ADDENDUM NUMBER 2

**DATE:** 1/8/2025

**PROJECT:** SEMCO Emergency Operations Center

# A611

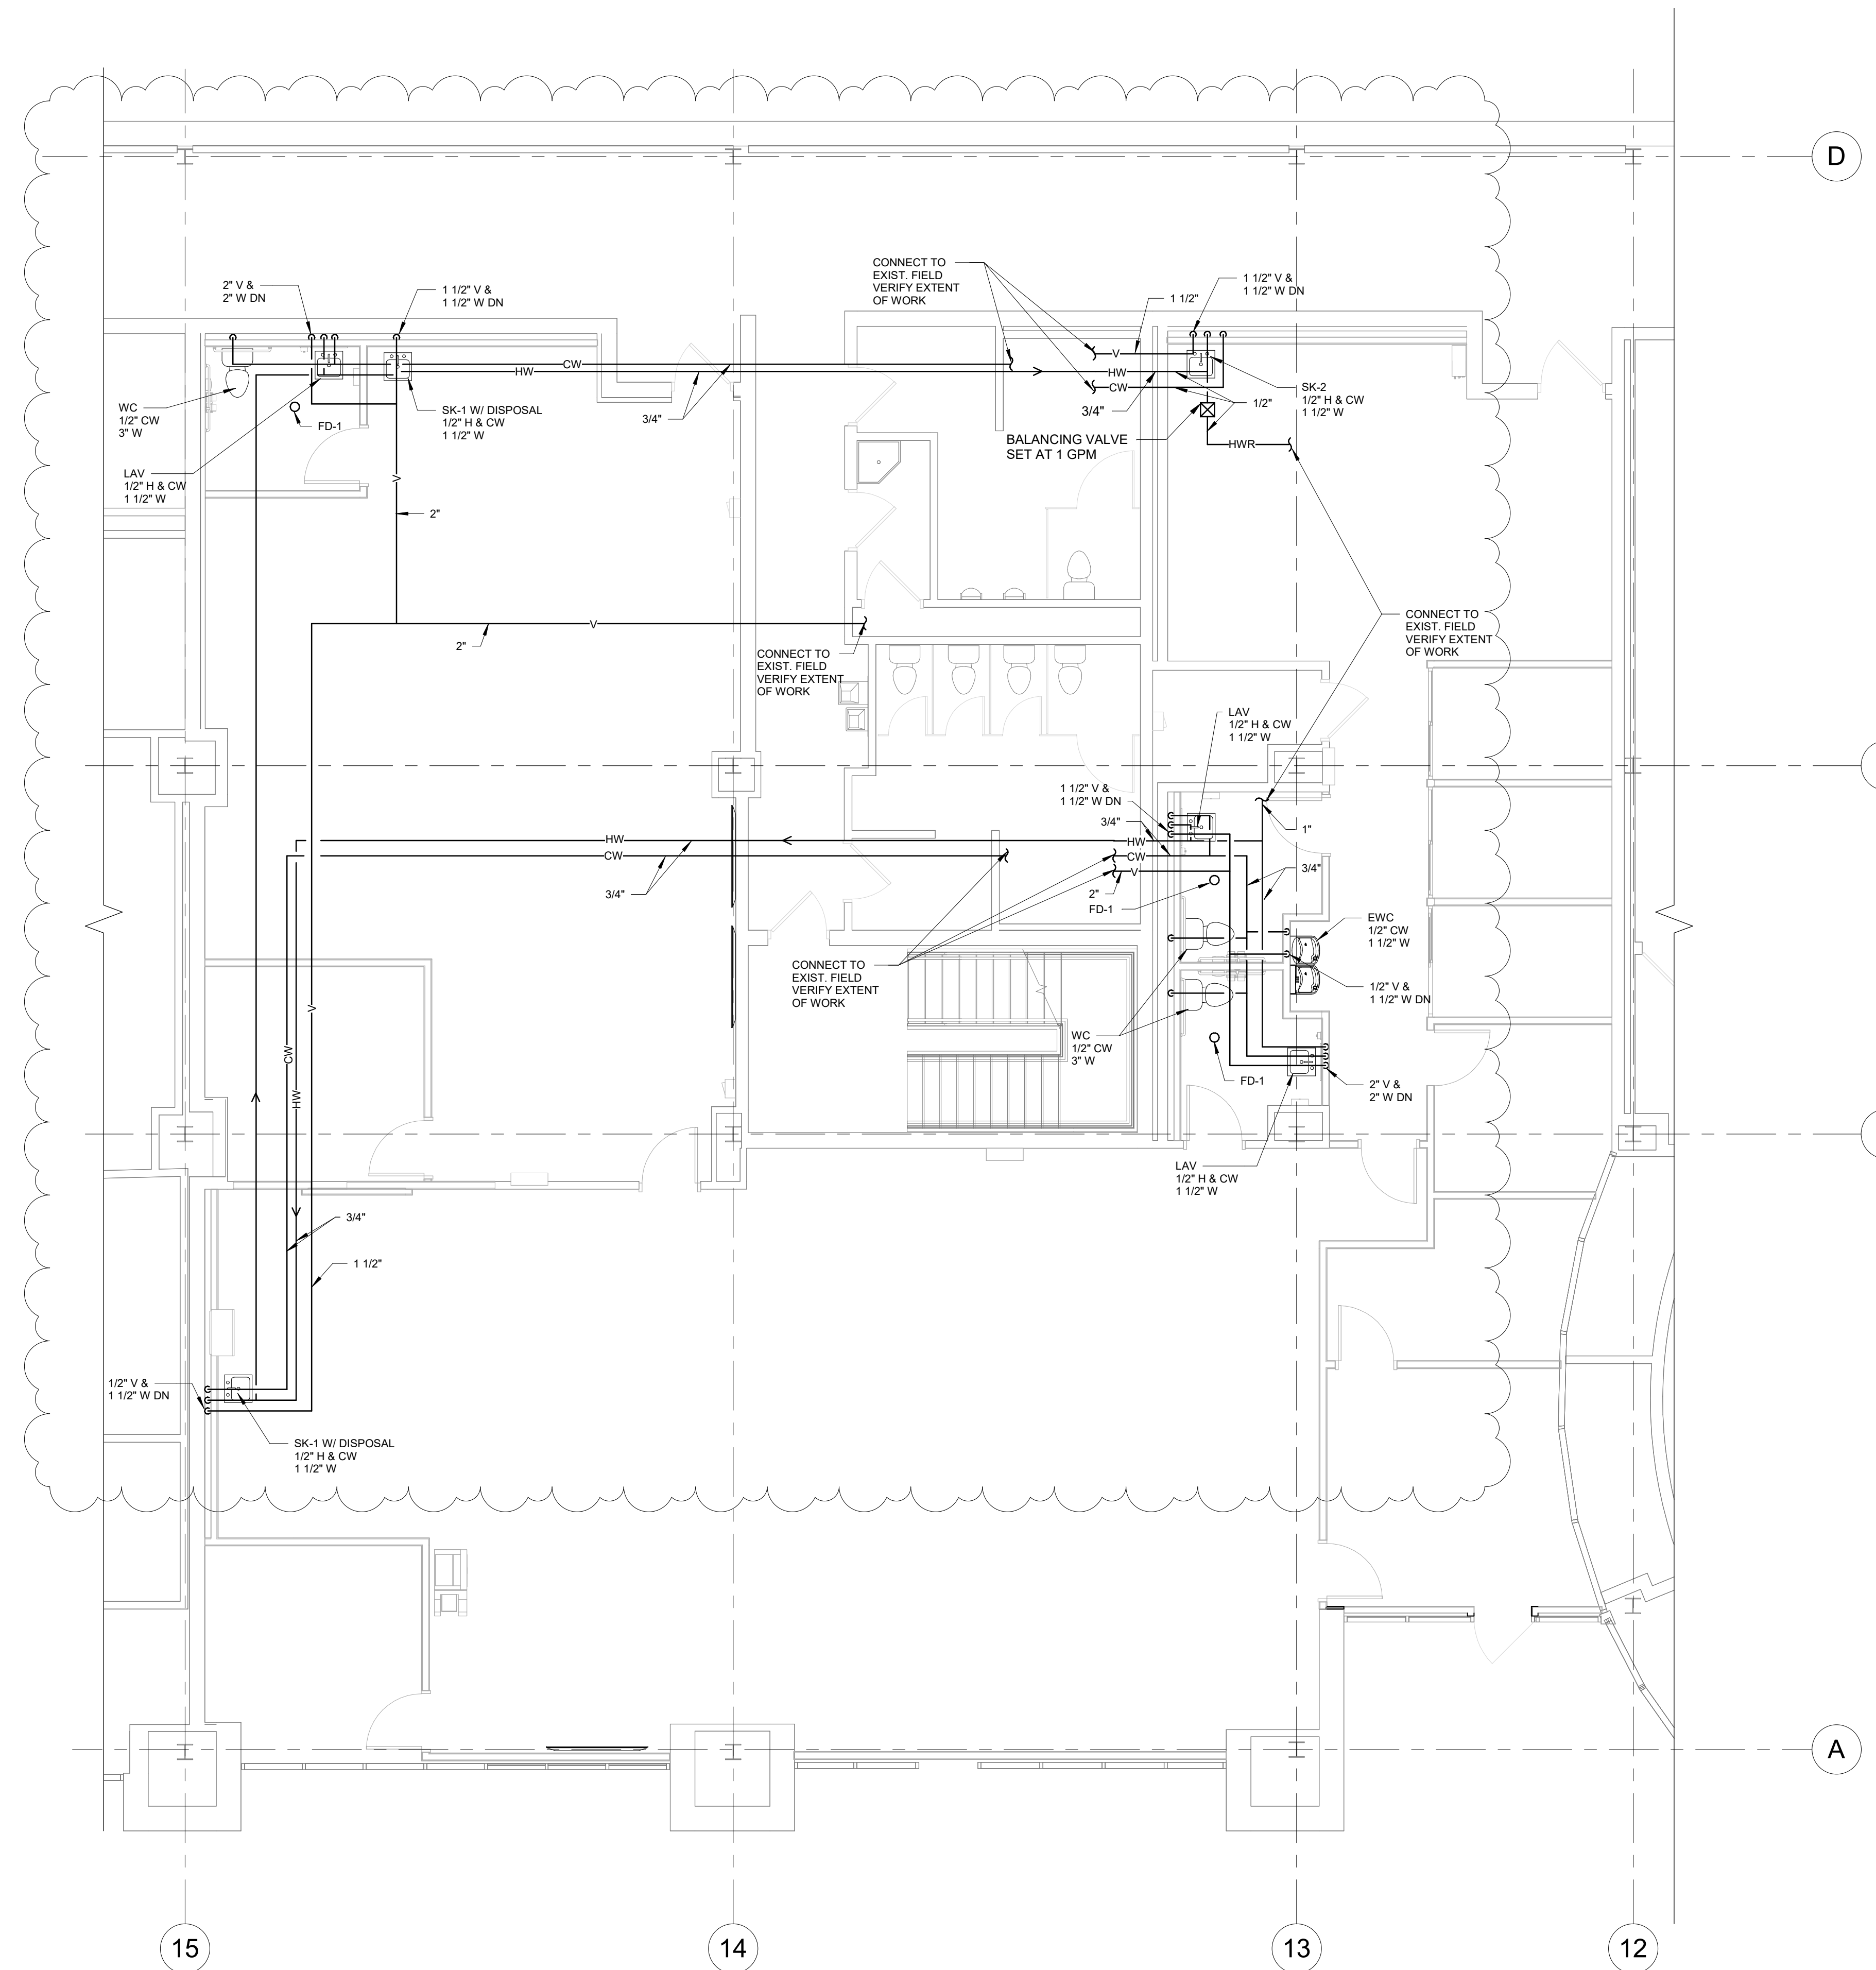
5. **Q:** Can you clarify if the Fatigue Room 108 is LVT or Carpet?  
**A:** Fatigue Room 108 is LVT.

1. SHEET A611: reissued
  - a. Fatigue Room floor finish changed in Room Finish Schedule to LVT-1

**E101**

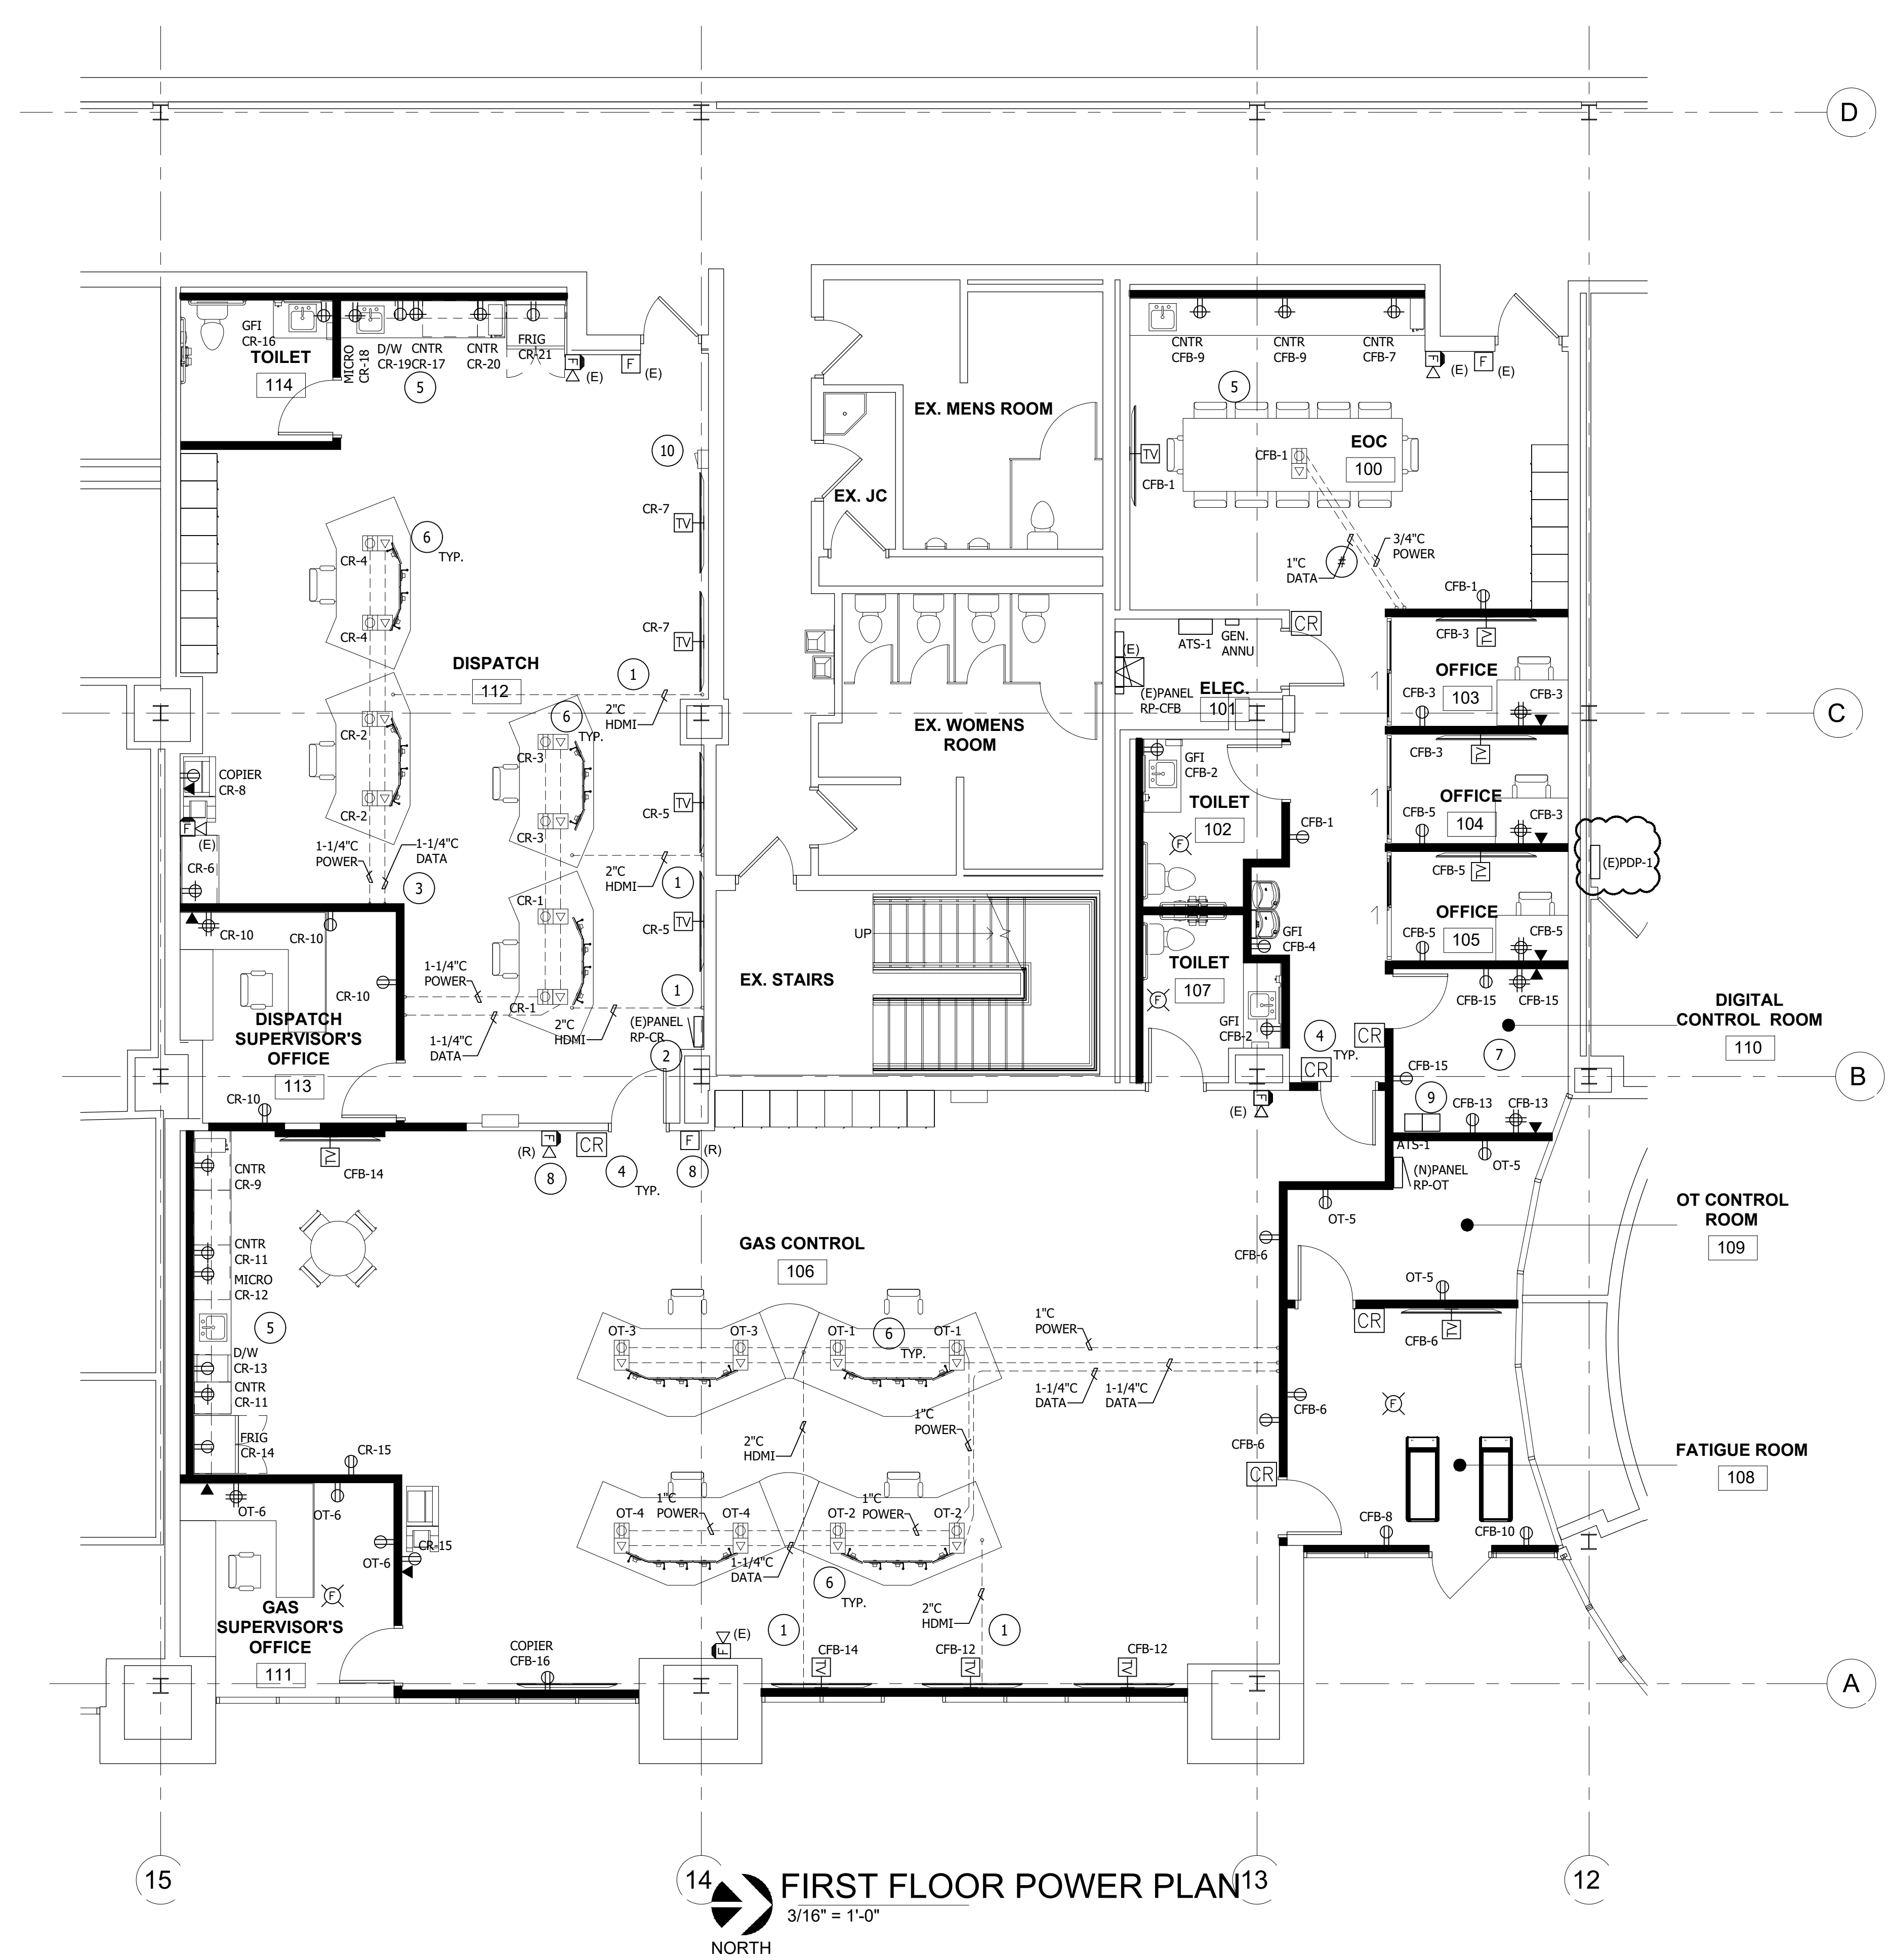
3. **Q:** Is there a composite drawing (Like drawing P102) showing the locations of electrical gear/panel "PDP-1" & "EMPD-P"?  
**A:** For Panel PDP-1, it is located on attached sheet E101. For Panel EMPD-P it is in the penthouse, and we do not have plans for that area.

1. SHEET E101: reissued
  - a. PDP-1 location
